PURPOSE : INFORMATION	ISSUE NO. : MSB-11E26-001	DATE : 2011-01-20
SUBJECT : DRIVESHAFT ASSEMBLY BOLT TIGHTENING TORQUE	<div> <div><MODEL></div> <div>(EUR)</div> <div>OUTLANDER</div> <div>(CW0W),</div> <div>ASX</div> <div>(GA0W)</div> </div> <div> <div><M/Y></div> <div>11</div> </div>	
GROUP : FRONT AXLE

In order to improve reliability, the bolt holding the right side driveshaft assembly to the adapter bracket has been changed for 4N1-2WD vehicles. Accordingly, descriptions in the applicable Workshop Manuals are changed. This Service Bulletin contains the modified descriptions.

ACA01605AB

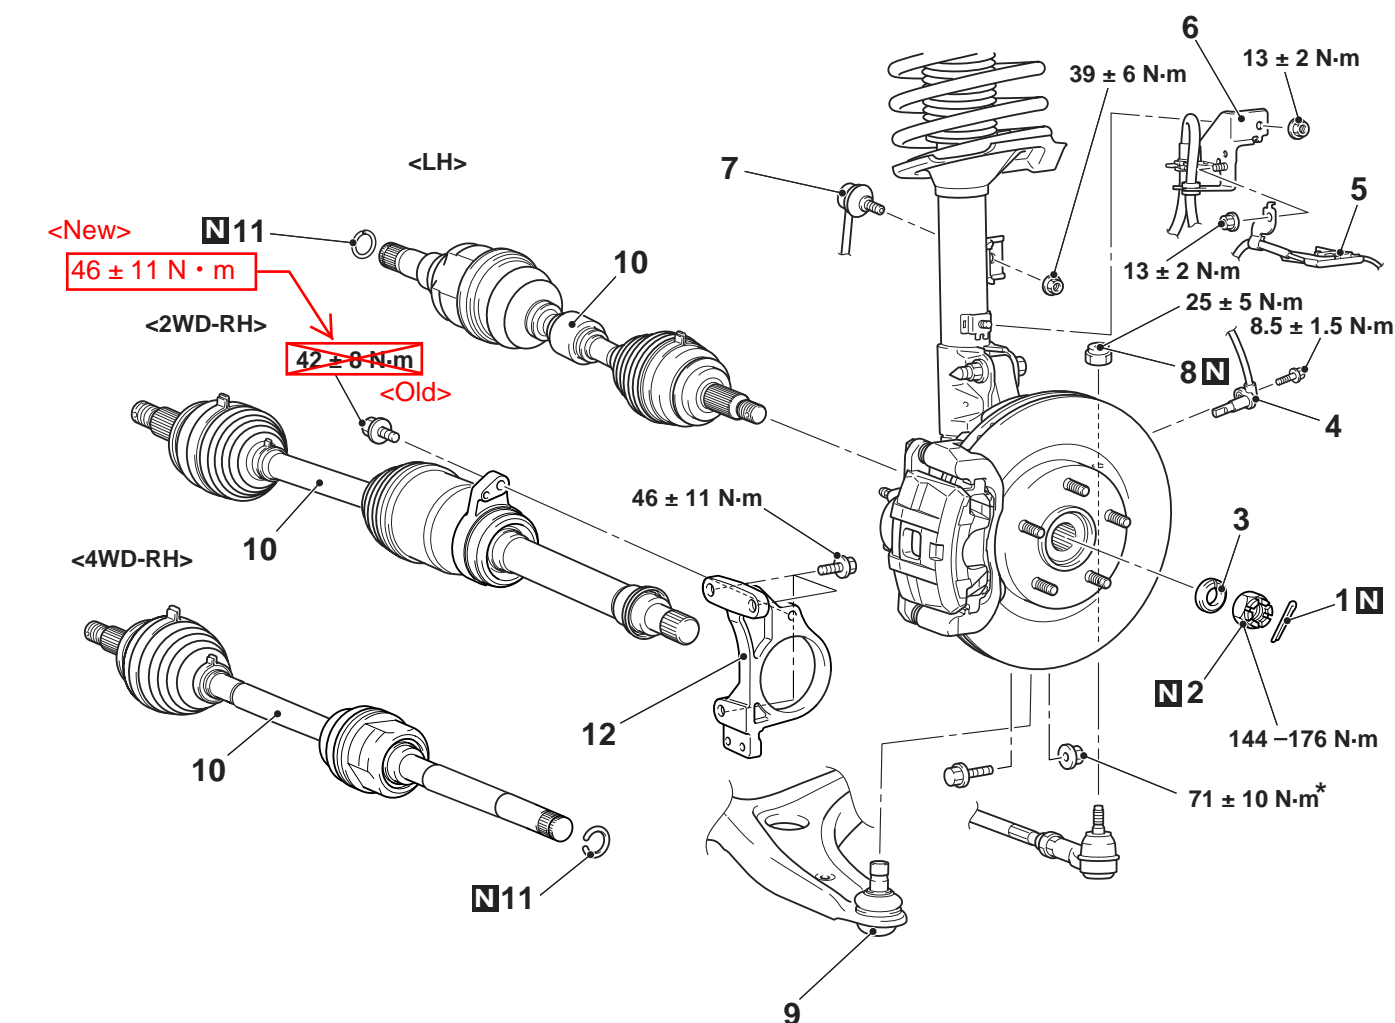
(1) Type of bolt is changed.

Current: Washer assembled bolt → New: Flange bolt

(2) Tightening torque is changed.

Current: 42 ± 8 N·m → New: 46 ± 11 N·m
